#### HISTORIC AND DESIGN REVIEW COMMISSION

#### December 19, 2018

**HDRC CASE NO:** 2018-617 **COMMON NAME: 100 LABOR STREET ADDRESS:** 600 E CESAR E CHAVEZ BLVD **LEGAL DESCRIPTION:** NCB 708 BLK 8 LOT 29 **ZONING:** RM-4, H **CITY COUNCIL DIST.:** 1 **DISTRICT:** Lavaca Historic District **APPLICANT:** Jim Bailey/Alamo Architects **OWNER:** San Antonio Housing Authority Construction of a multi-family residential development **TYPE OF WORK: APPLICATION RECEIVED:** November 20, 2018 **60-DAY REVIEW:** January 29, 2019

#### **REQUEST:**

CONCEPTUAL LANDSCAPE PLAN

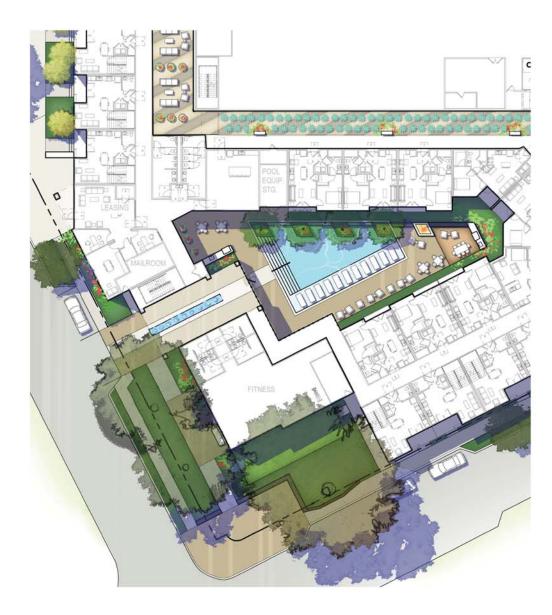
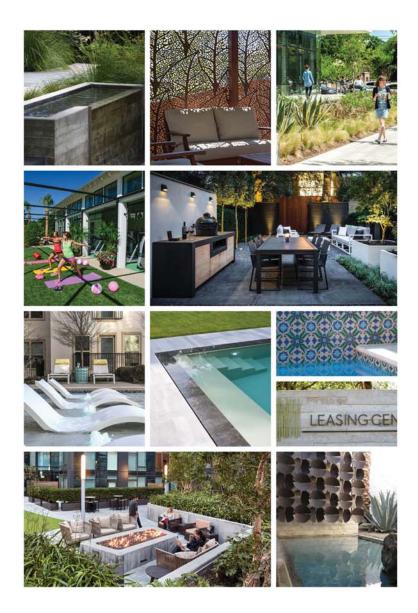
- p. LANDSCAPING At this time, the applicant has provided a conceptual landscaping plan that appears to be appropriate for the context of this site and consistent with the Guidelines. When returning to the HDRC, the applicant is to submit a detailed landscaping plan.

- ii. That a detailed landscaping and lighting plan be submitted when returning for final approval as noted in finding p.
- iii. That all mechanical equipment be screened from view as noted in finding m.
